# NUCLEAR REGULATORY COMMISSION

# Title: Advisory Committee on Reactor Safeguards AP1000 Subcommittee: Open Session

Date: Wednesday, September 17, 2014

## Staff Findings – Containment Impact

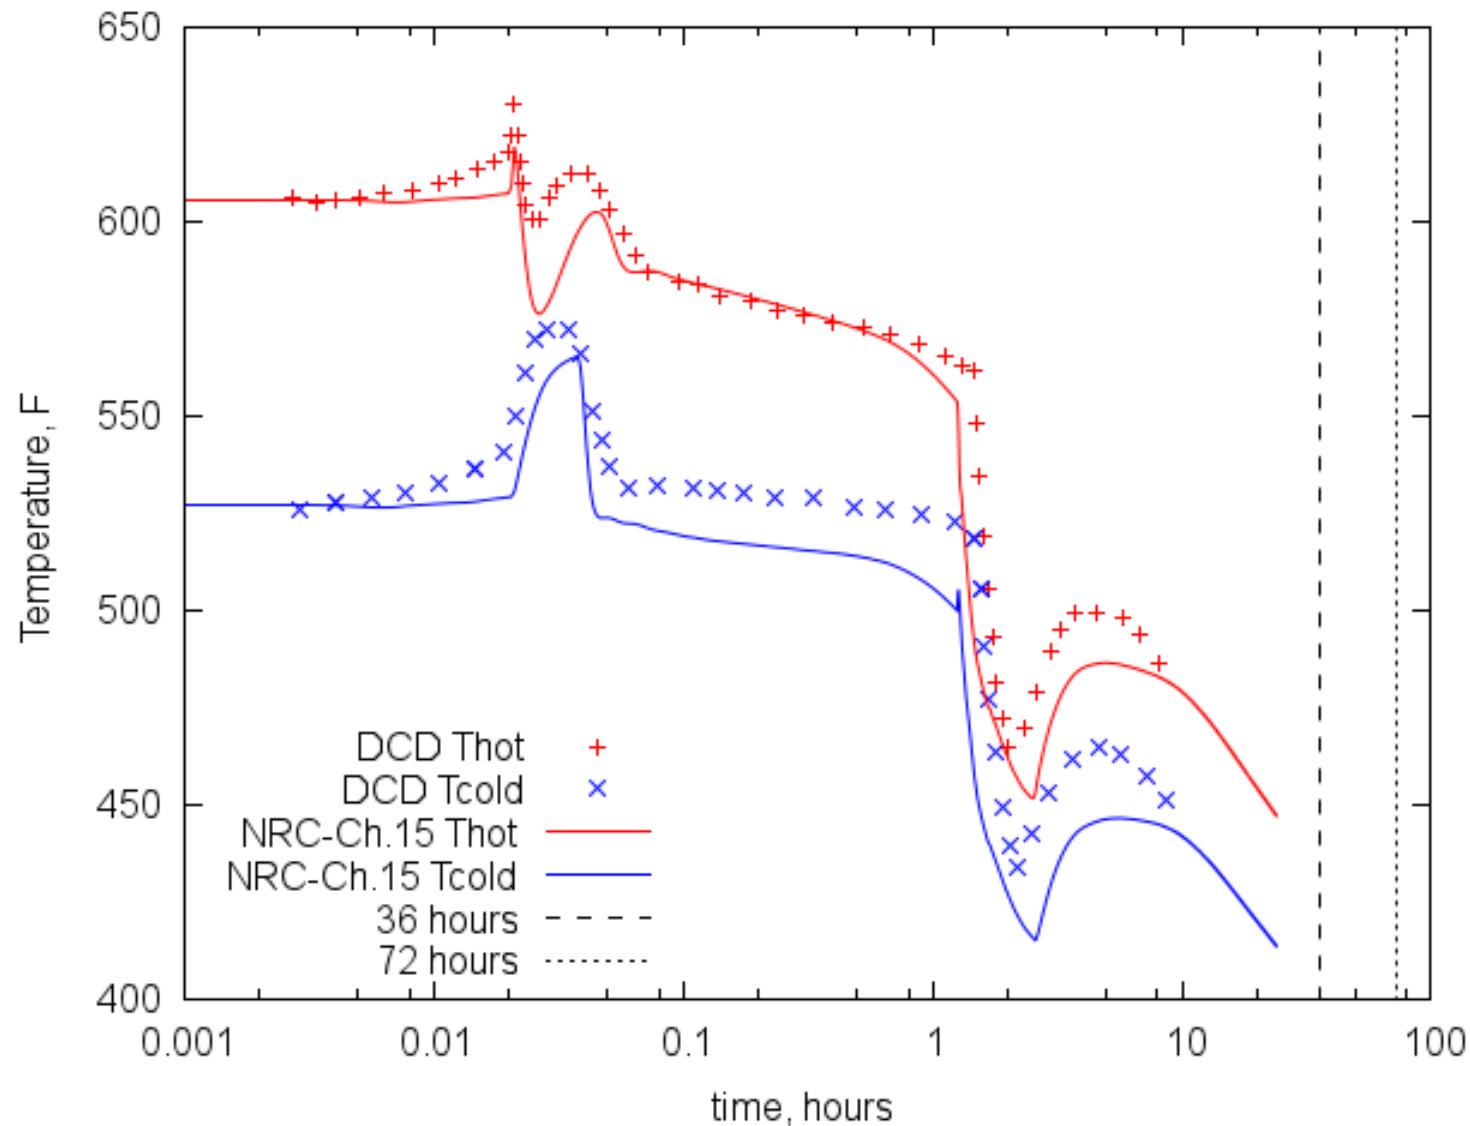
- Holdup
  - Determination of total holdup
  - Film thickness
    - Staff questioned applicability of approximation used in submittal (RAI 7439, 06.03-3)
    - Applicant re-evaluated film thickness, performed sensitivity study for more film holdup; negligible effect on the performance of the PRHR-HX during the first 72 hours
- Determination of condensate return rate
  - Losses over wall attachments
    - Staff asked applicant to justify correlation for wall losses from testing (RAI 7439, 06.03-5) - Applicant tested losses over wall attachments at non-prototypic temperatures, extrapolated
    - Applicant performed sensitivity studies for increased wall losses, indicated almost no impact on first 72 hours and small reduction in long-term (beyond 72-hour) mission time

- Containment peak pressure unchanged
- Containment floodup level following ADS actuation or LOCA for containment recirculation not adversely affected
- Potential lowered IRWST level following PRHR-HX actuation does not challenge ADS 1/2/3 actuation
- The PXS downspout screens are AP1000 safety class C, seismic Category I components and will meet the QA requirement of 10 CFR Part 50, Appendix B. Existing ITAAC design commitments also apply.
- The PXS downspout piping are AP1000 safety class C, seismic Category I piping, designed to ASME Code Section III and will meet the QA requirement of 10 CFR Part 50, Appendix B. Existing ITAAC design commitments also apply.

## Review Focus – PXS Safety Design Basis

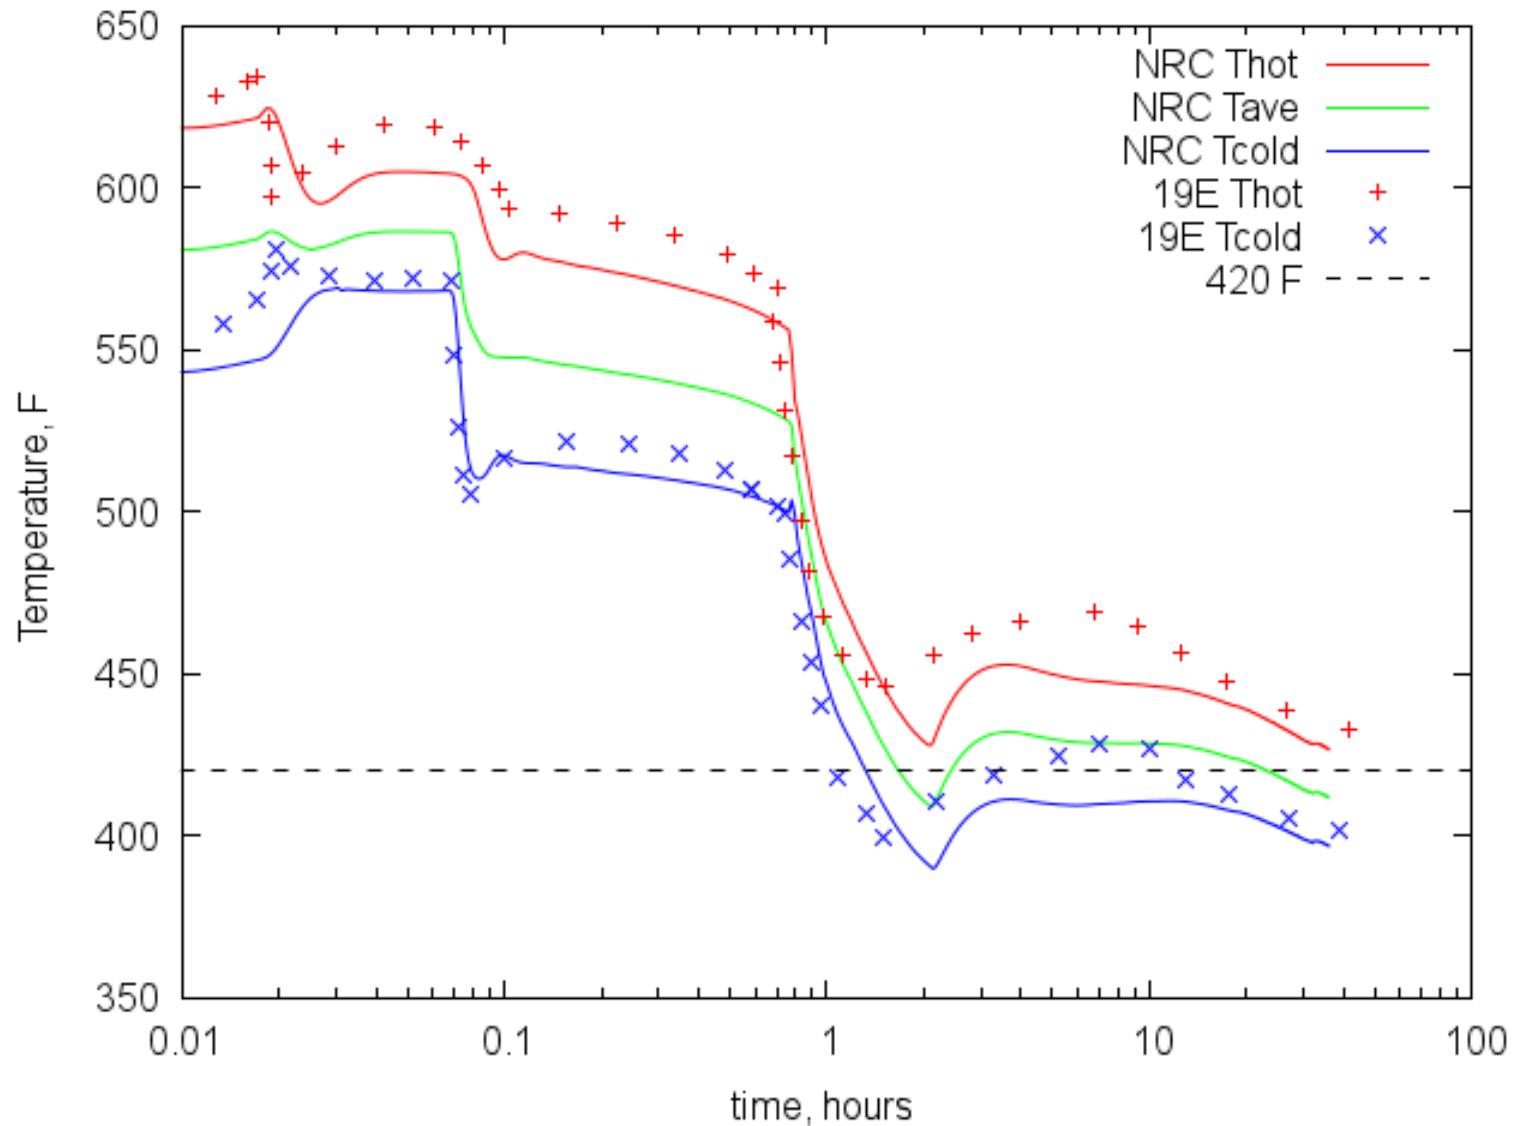
- Emergency makeup/boration
  - No impact
- Safety injection
  - Transition to open loop cooling is retained as defense-in-depth
  - No minimum level in IRWST is required for transition to open loop cooling
- Containment pH control
  - No impact
